Access Compliance Report

Public Rights-of-Way

(Curb Ramps)

Intersection ID: 16670	Main Street: BEVERLY_DR	Cross Street: PROVIDENCE_RD	Location: SW
ADA ID: 24DF8EB5B220	Ramp Type: Perp	Initial Pass/Fail: Fail	Overall Compliance: No
Severity Score: 8.75			
Codes/Mitigation Info/Possible Solution		Field Measurements/Component Compliance

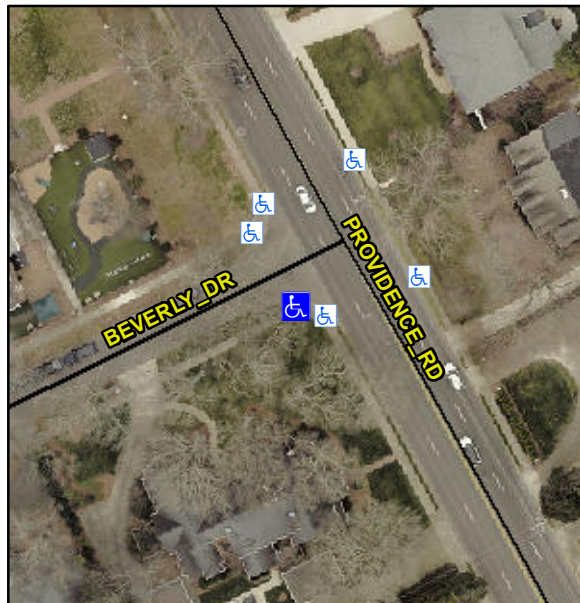
Not Found, R304.5.1

Compliance	Description	Data	Compliance	Description	Data
N/A	Ramp Length (in)	61.0	Yes	Ramp Slope (%)	6.1
No	Ramp Width (in)	45.0	Yes	Ramp XSlope (%)	1.2
N/A	Flare Type LT	N/A	N/A	Flare Type RT	N/A
N/A	Flare Slope LT (%)	N/A	N/A	Flare Slope RT (%)	N/A
N/A	Flare Traversable LT?	N/A	N/A	Flare Traversable RT?	N/A
N/A	Landing Length (in)	N/A	N/A	DWS Provided?	N/A
N/A	Landing Width (in)	N/A	N/A	DWS Contrast?	N/A
N/A	Landing Slope (%)	N/A	N/A	DWS Length (in)	N/A
N/A	Landing X Slope (%)	N/A	N/A	DWS Full Width?	N/A
N/A	Landing Curb? (Y/N)	N/A	N/A	DWS Offset (in)	N/A
N/A	Shared Landing?	N/A			
N/A	Gutter Ponding?	N/A	N/A	Gutter Slope (%)	N/A
N/A	Gutter Lip Ht (in)	N/A	N/A	Gutter X Slope (%)	N/A
N/A	Painted X Walk1?	No	N/A	Painted X Walk2?	N/A
	X Walk 1 Direction	To NW		X Walk 2 Direction	N/A
N/A	X Walk 1 Width (in)	N/A	N/A	X Walk 2 Width (in)	N/A
	X Walk 1 Slope (%)	3.9		X Walk 2 Slope (%)	N/A
	X Walk 1 X Slope (%)	0.9		X Walk 2 X Slope (%)	N/A

Remove & Replace Entire Ramp.
